APPROVED MINUTES

September 15, 2011 Standards Committee Meeting

RE: Minutes for the September 15, 2011 Standards Committee Meeting

PROPOSED RECURRING PLAN DETAILS 805-T-1XX MICROLOOP DETECTOR PROBES CROSS SECTION DETAIL

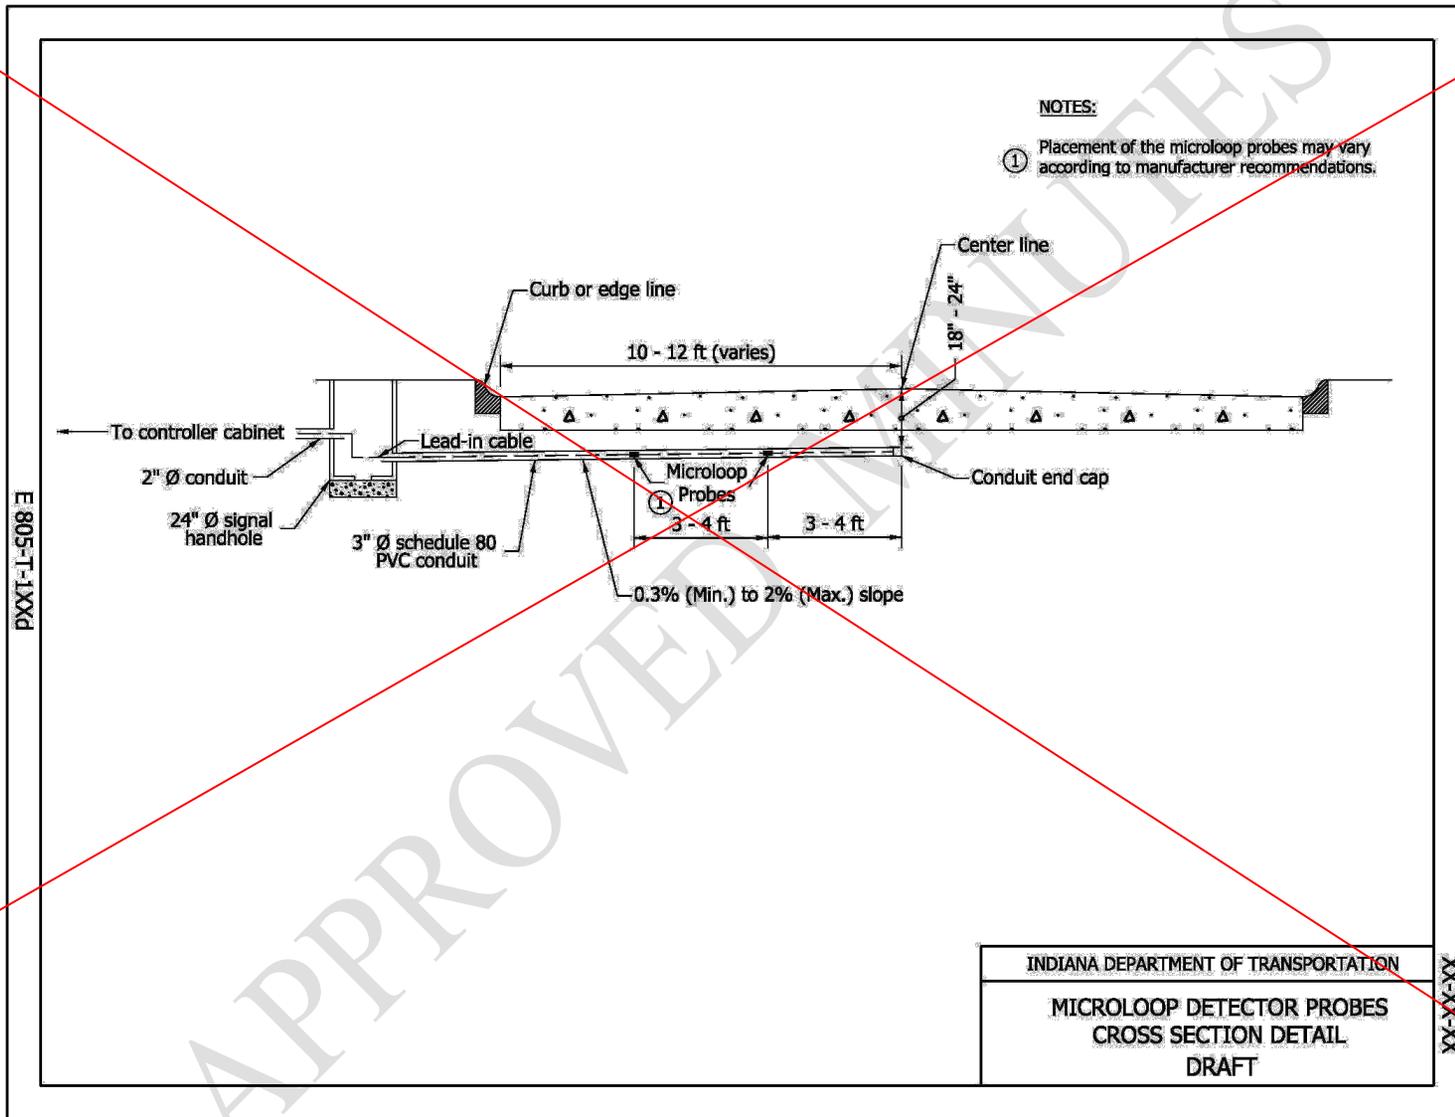
Mr. Pankow also addressed the reference to pushing the conduit under the existing pavement and expressed concern over damaging the integrity of that pavement. Mr. Bruno responded that the following sentence instructs the Contractor to repair any damaged pavement. A brief discussion revealed that the reference to the 18 to 24 in on the standard drawing is acceptable.

Mr. Andrewski inquired as to the location of the handhole as shown on the standard drawing. Mr. Pankow commented that we should make this as generic as we can. Should we also take out the curb? Mr. Bruno said that we can show it off the edge of the pavement, and not show the curb or shoulder. Mr. Andrewski also suggested removing the dimension showing 10 to 12 ft (varies).

Further discussion then ensued concerning the slope of the conduit, to make sure there is positive drainage. Mr. Andrewski mentioned that often times the turn lanes slope more than the travel lanes, and may make it difficult to maintain the 18 to 24 in depth. Mr. Keefer asked if we need this drawing at all since now there isn't much left on the drawing due to all the revisions, and recommended throwing away the drawing. Mr. Keefer also recommended putting the language back into the spec concerning depth and slope and then removing the drawing. Mr. Bruno said he would be okay with that. Mr. Pankow said that everyone needs to be okay with what the manufacturer recommends. The group agreed to get rid of the drawing and unstrike what was previously struck out in section 922.13(d).

Also discussed was the reference to the temperature rating exceeding 300 deg F. The revision to 922.13(c) as approved by the group is as shown above. Also, note 2 in 922.13(d) was revised to remove the language for ~~3-in. diameter schedule 80 PVC~~ since it is already shown on the standard drawing.
